Our Ref: FPEM/0952/2022
Date: 29th November 2022
Enquiry: Four HVDC cables from Devon coast at Cornborough to a pair of new converter stations and twelve HVAC cables to new equipment
Location: Land At Grid Reference 249722 123624, Weare Giffard, Devon,

I write further to the second pre-application enquiry regarding the X-Links project. This response should be read as an update to the original pre-application response (FPEM/0372/2021). The pre-application response in connection with FPEM/0372/2021 sought to appraise the location of the cable route and the site subject of the converter stations, including consultation comments to inform any future submission. The majority of these comments remain relevant, as much of the project remains unchanged with the exception of the converter station location.

FPEM/0952/2022 - Land Between Cornborough and Gammaton Moor - Xlinks UK Onshore Development

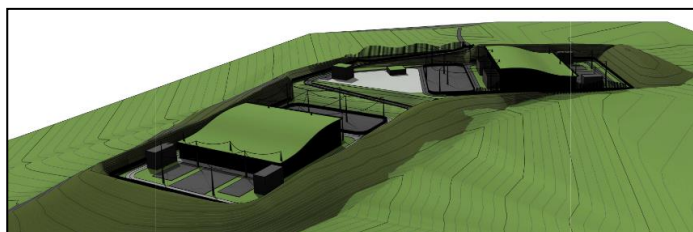
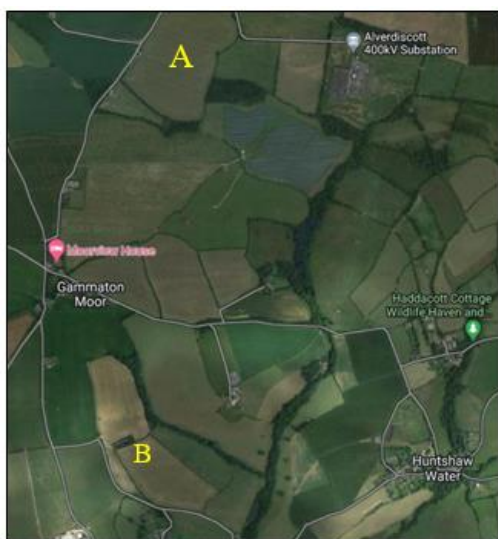
The location of the converter stations was amended for the purposes of this pre-application enquiry, following the negative pre-application advice given previously (FPEM/0372/2021). As per the image below, site A denotes the location submitted with FPEM/0372/2021 whilst Site B denotes the site submitted as part of this enquiry.

With reference to Site B, the chosen site is considered to be more suitable due to its typography, which provides a good baseline for any prospective re-development, subject to a LVIA review and formalised drawings/mitigation. The Council find the site subject of this enquiry to be preferred for that reason, and maintain some concern regarding Site A, particularly regarding its prominence in landscape terms. The Council however recognise that ultimately site selection is a decision to be made by the applicant, informed by their own landscape consultants. Once further information has been provided, the Council would continue to engage with an externally appointed landscape expert in order to review the significance of any landscape impact, as required by Policy DM08A, national policy, and underpinned by the appropriate evidence. It is still considered likely that there will be a significant shift in character, noting the prevalence of pylons and approved solar panel applications, which cumulatively have the potential to create an impact upon the local landscape. This, however, will be weighed in the balance in the determination of the application. Therefore, a site which is less prominent would be considered to be of benefit, in noting this potential cumulative impact and limiting any long-distance views as much as possible. It is noted that you will have engaged with the Pete Leaver (Landscape Consultant, instructed on behalf of TDC) directly. In more general terms, the design concept shows an array of options which appear to be well-thought out, aiming to limit the impact with design-led solutions and mitigation. The Council welcomes the site-led design approach and notes the inclusion of 'cut and fill' techniques.

Figure 2.

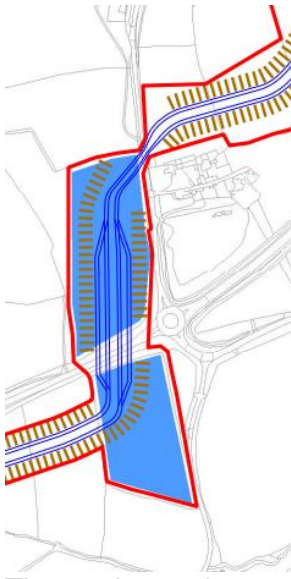
In this location the compound area at Abbotsham cross covers the site of a windmill identified in a heritage appraisal on the Clovelly road south site and this will need to be recorded before any site disturbance.

The routing and compounds where the cable crosses the river has potential to impact on the view into Bideford and the views from Landcross to Tennacott are a main viewpoint from the a388 and the level of visual harm to the views into Bideford will need to be assessed as part of a wider heritage assessment

Fig 2e

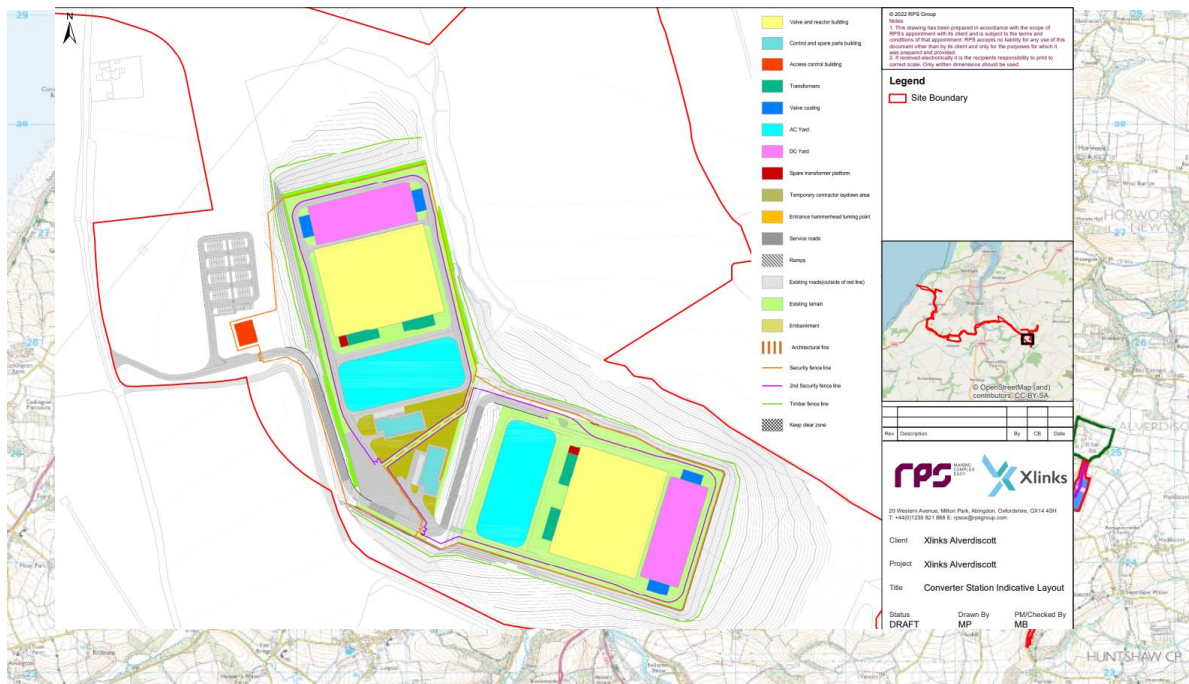
The termination of the route with the converter station will need more detailed justification and assessment as the scale of the building within the steep sided valley leading down to the stream that feeds Huntshaw Mill and the on to the Torrige . The proximity to the listed farmstead at Great Huxhill will require a more detailed consideration of the siting and how the proposed earth works to assimilate the converter station at the head of the valley will impact on the setting of this historic farmstead.
